UNITED STATES  
DEPARTMENT OF THE INTERIOR  
BUREAU OF LAND MANAGEMENTFORM APPROVED  
OMB NO. 1004-0135  
Expires: July 31, 2010**SUNDRY NOTICES AND REPORTS ON WELLS**  
*Do not use this form for proposals to drill or to re-enter an abandoned well. Use form 3160-3 (APD) for such proposals.***SUBMIT IN TRIPLICATE - Other instructions on reverse side.**

LINN OPERATING, INC. RESPECTFULLY REQUESTS TO PA THIS WELL. PLEASE NOTE THAT THIS WELL FAILED THE 5 YEAR MIT DUE TO NOT HOLDING PRESSURE AND WAS IN VIOLATION STATUS. SEE ATTACHED PLUGGING PROCEDURE, CURRENT AND PROPOSED WELL BORE DIAGRAMS.

SKELLY UNIT #56  
(API 30-015-05350)  
PROPOSED PA PROCEDURE

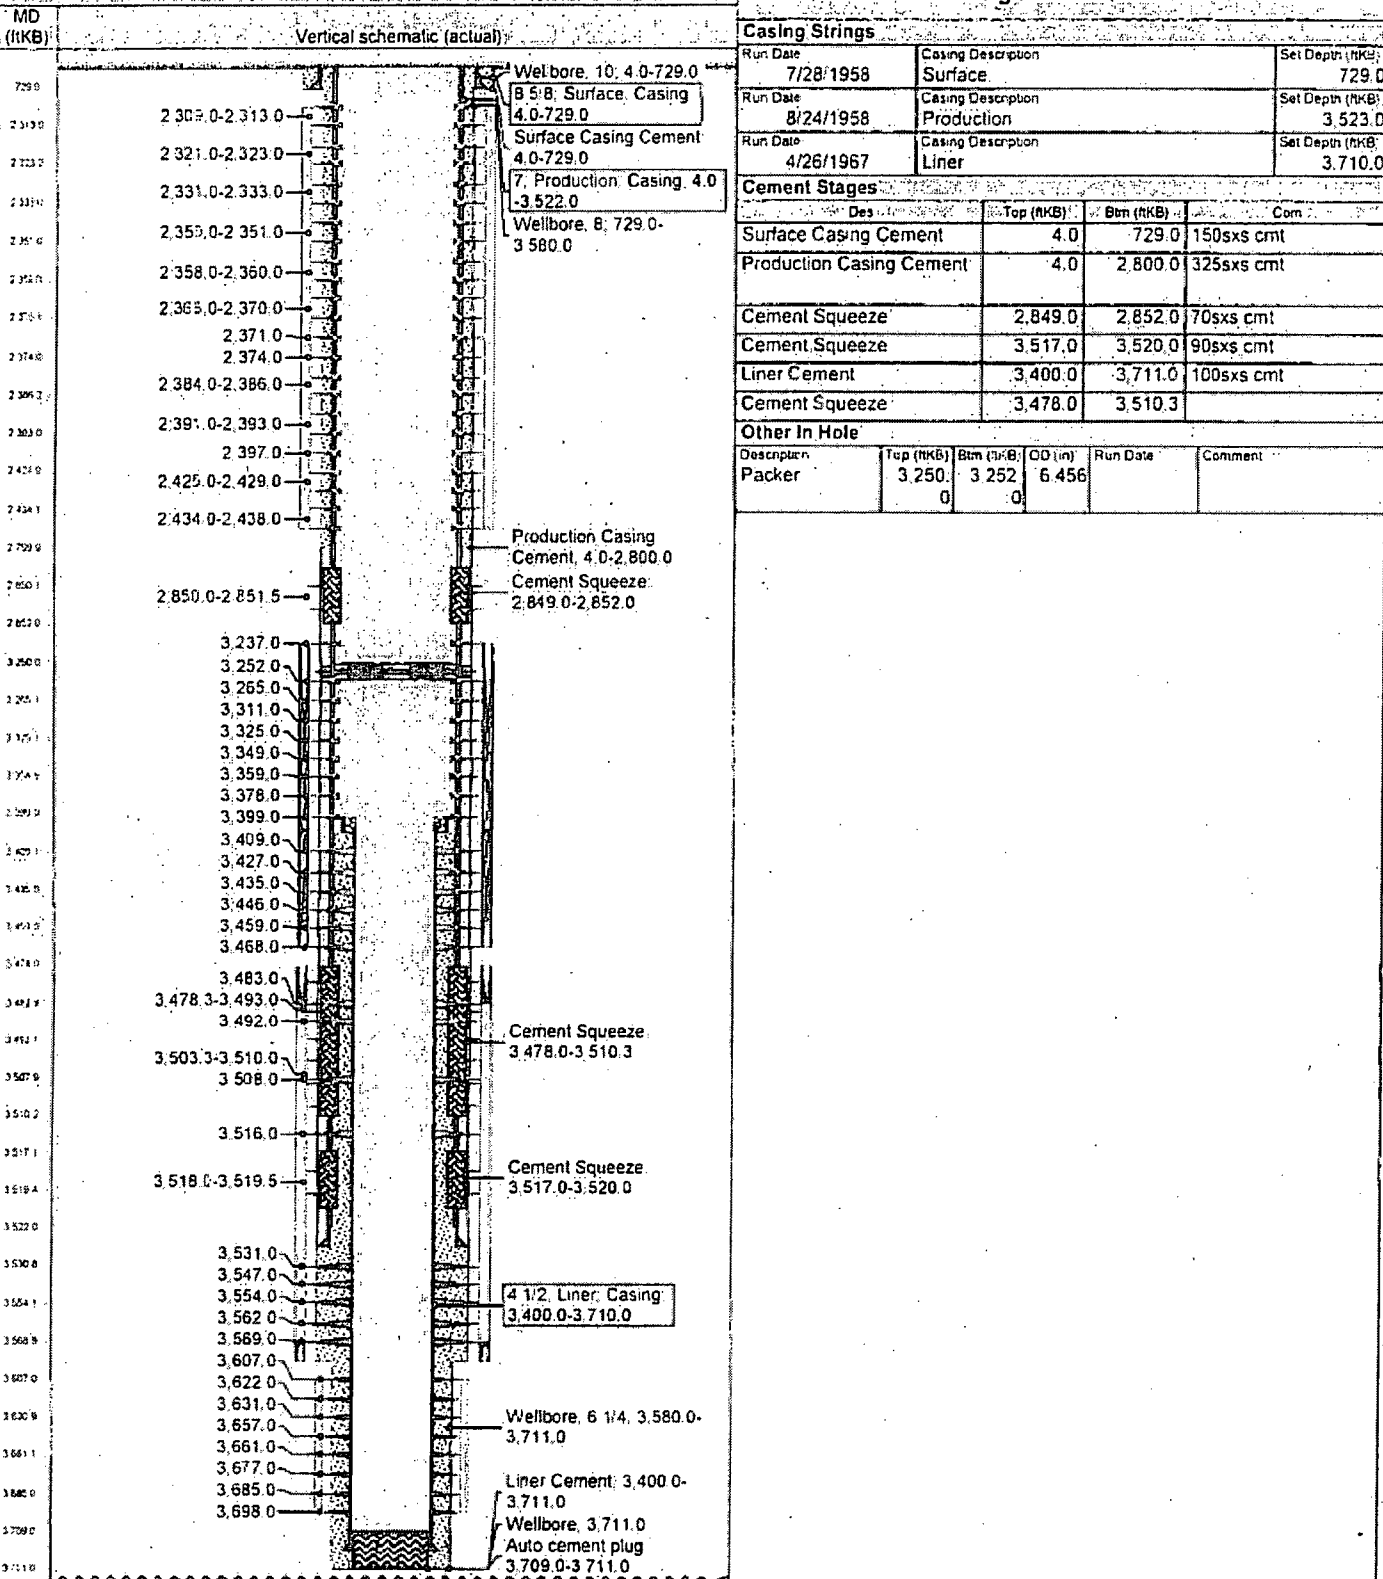
*Below ground level day hole marker required.*

At cut off verify cnt to surface all annulus.
